- SUBJECT:** LANDING GEAR (MAIN GEAR ASSEMBLY) – MODIFICATION AND ADJUSTMENT OF MAIN LANDING GEAR ACTUATOR
- EFFECTIVITY:** BEEHCRAFT Sierra A24R, serials MC-2 through MC-76, MC-81 through MC-106, MC-110 through MC-112, MC-116 through MC-119 and MC-122.

- REASON:** To ensure security and proper adjustment of the main gear actuator.
- COMPLIANCE:** As soon as practical but no later than the next scheduled inspection.

LANDING GEAR ACTUATOR MODIFICATION

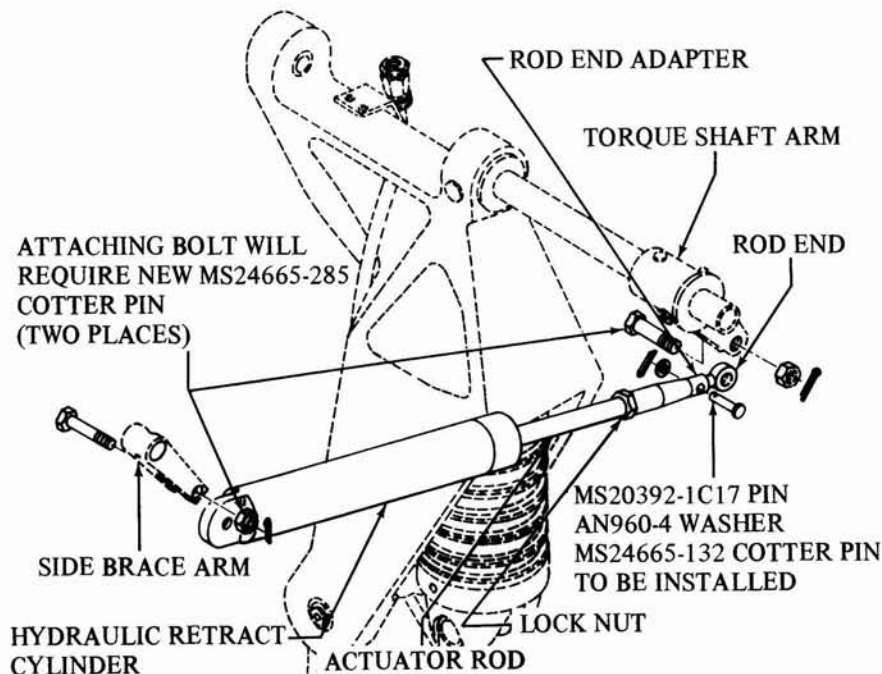
7. Screw the rod end out of the adapter until the threaded end is just visible at the inspection hole in the adapter.
8. Screw the rod end into the adapter three complete turns. While holding the rod end and the adapter securely in this position, drill a .125/.128 inch diameter hole through the adapter and rod end at a location which is 90° to the inspection hole and .19 inches forward (toward the rod end).

9. Install an MS20392-1C17 Pin, AN960-4 Washer and MS24665-132 Cotter Pin in this hole.
10. Screw the adapter assembly onto the actuator rod to approximately the same depth as it was prior to removal.

12. Extend the cylinder until the piston bottoms out and screw the hydraulic cylinder actuator rod into or out of the adapter as required so that, with the piston bottomed out, the outboard cylinder attach bolt can be freely inserted into position. Install the bolt and nut and safety with a new MS24665-285 Cotter Pin.

13. Turn the actuating rod counter clockwise (outward) in the rod end adapter TWO COMPLETE TURNS and secure the locknut into position.
